**Subject:** Today's agenda items 6.2, 6.3, and 6.4

re: San Jose to Merced Project Section State's Preferred Alternative

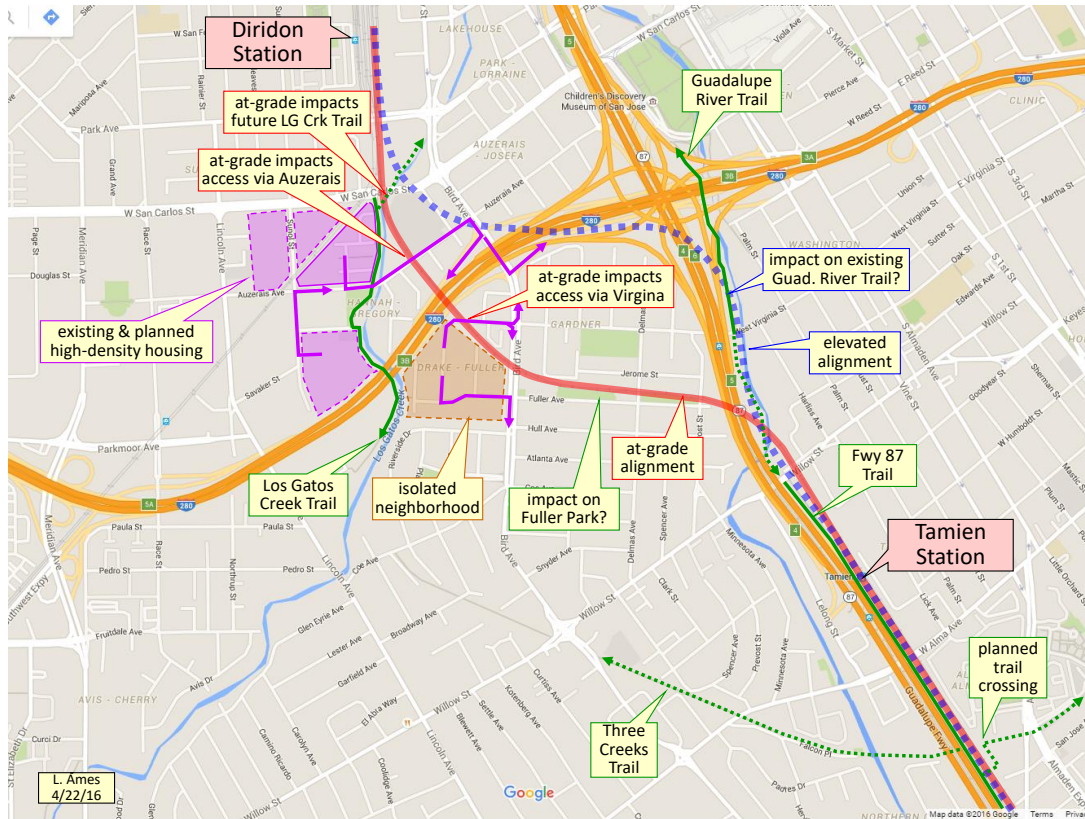
- As I and many others have been saying for years, it is critical for the Greater Gardner and North Willow Glen neighborhoods in San Jose that you select an "elevated" approach from the Tamien Station to the San José/Diridon Station rather than the "at-grade" alignment of Alternative 4. As shown in red in the diagram below, the at-grade alignment would have the daily rush of trains run right through a well-established community, one that is already feeling the impacts of Freeways 280 and 87 and the noise of the recently-expanded nearby airport. The at-grade rail alignment would also impact traffic access to a number of neighborhoods. Adding the needed 3rd set of tracks would probably require taking land from Fuller Park. And the alignment itself, given its close sequence of curves are straight sections, would give passengers an uncomfortably jerky ride. The elevated alternative (shown in dotted blue) stays mainly within the confines of the freeway sound walls: the only private parcels impacted are a few mainly old or empty

commercial lots by Bird Ave. on the north side of the freeway. And being elevated over Bird and within the freeway right-of-way elsewhere avoids traffic impacts to the neighborhoods.

- As shown in my diagram, the HSR alignment will cross a number of existing and planned bike paths, shown in green. Note that these trails allow your customers to reach the station without adding to the area’s traffic congestion: they should be accommodated and encouraged.
